# Access Compliance Report

## Public Rights-of-Way

### (Curb Ramps)

Intersection ID: 17009	Main Street: N_WENDOVER_RD	Cross Street: RANDOLPH_RD	Location: W
ADA ID: 986982A6AF61	Ramp Type: Perp	Initial Pass/Fail: Fail	Overall Compliance: No
Severity Score: 33.75			
Codes/Mitigation Info/Possible Solution		Field Measurements/Component Compliance

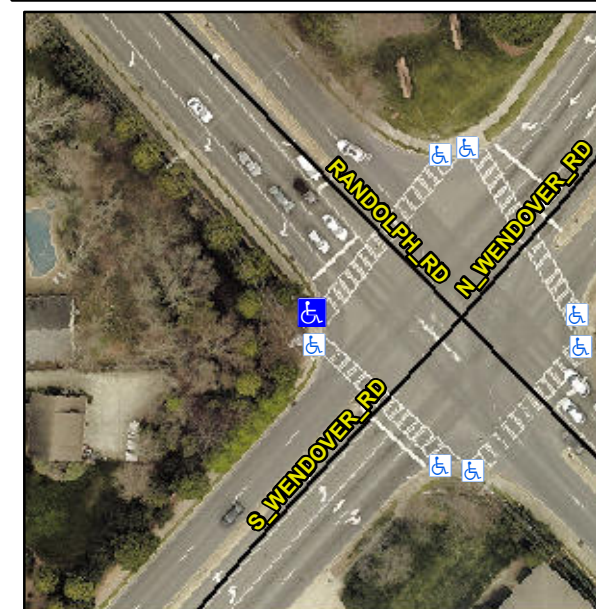
**R304.5.1, R304.5.3**

Compliance	Description	Data	Compliance	Description	Data
N/A	Ramp Length (in)	82.5	Yes	Ramp Slope (%)	7.8
No	Ramp Width (in)	46.0	No	Ramp XSlope (%)	7.3
N/A	Flare Type LT	N/A	N/A	Flare Type RT	N/A
N/A	Flare Slope LT (%)	N/A	N/A	Flare Slope RT (%)	N/A
N/A	Flare Traversable LT?	N/A	N/A	Flare Traversable RT?	N/A
N/A	Landing Length (in)	N/A	N/A	DWS Provided?	N/A
N/A	Landing Width (in)	N/A	N/A	DWS Contrast?	N/A
N/A	Landing Slope (%)	N/A	N/A	DWS Length (in)	N/A
N/A	Landing X Slope (%)	N/A	N/A	DWS Full Width?	N/A
N/A	Landing Curb? (Y/N)	N/A	N/A	DWS Offset (in)	N/A
N/A	Shared Landing?	N/A			
N/A	Gutter Ponding?	N/A	N/A	Gutter Slope (%)	N/A
N/A	Gutter Lip Ht (in)	N/A	N/A	Gutter X Slope (%)	N/A
N/A	Painted X Walk1?	Yes	N/A	Painted X Walk2?	N/A
	X Walk 1 Direction	To NE		X Walk 2 Direction	N/A
N/A	X Walk 1 Width (in)	113.0	N/A	X Walk 2 Width (in)	N/A
	X Walk 1 Slope (%)	0.4		X Walk 2 Slope (%)	N/A
	X Walk 1 X Slope (%)	5.6		X Walk 2 X Slope (%)	N/A

**Remove & Replace Entire Ramp.**
